# Amphenol PCD

<b>Engineering Change Request</b>		ECR Number	26003W	
Initiator:	Kane	Date:	2026.03.19	
Part number description				
Item	K3 Code <b>material part numbers</b>	Drawing/ Doc Number	Version of current related document	New Version
1	MSD Series	/	/	/
2	HVSL630 Series	/	/	/
3	HVSL280 Series	/	/	/
4	HVSL600 Series	/	/	/
Reason of change:				
<input type="checkbox"/> Customer requirement (list the feasibility analysis of customer specification: _____)				
<input type="checkbox"/> Supplier request (list the PCR number: _____ )				
<input type="checkbox"/> internal improvement <input type="checkbox"/> corrective <input checked="" type="checkbox"/> other				
<u>Please describe here in detail:</u>				
<b><u>Item 1–4: The current grey PA66 plastic raw material used in this product series is no longer available with reliable supply due to force majeure events. To ensure uninterrupted production and maintain consistent functional performance, we will transition to black PA66 plastic as a fully qualified substitute. Consequently, the housing color of the affected components will be standardized to black.</u></b>

**Item 2 HVSL630 Series**

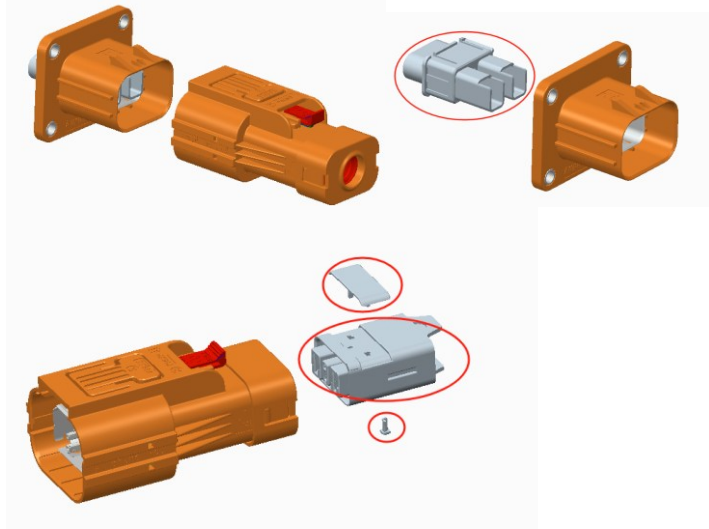
**Before change**  
The plastic raw material supplier is Sabic.  
(Grey)

**After change**  
The plastic raw material supplier is DOMO.  
(Black)
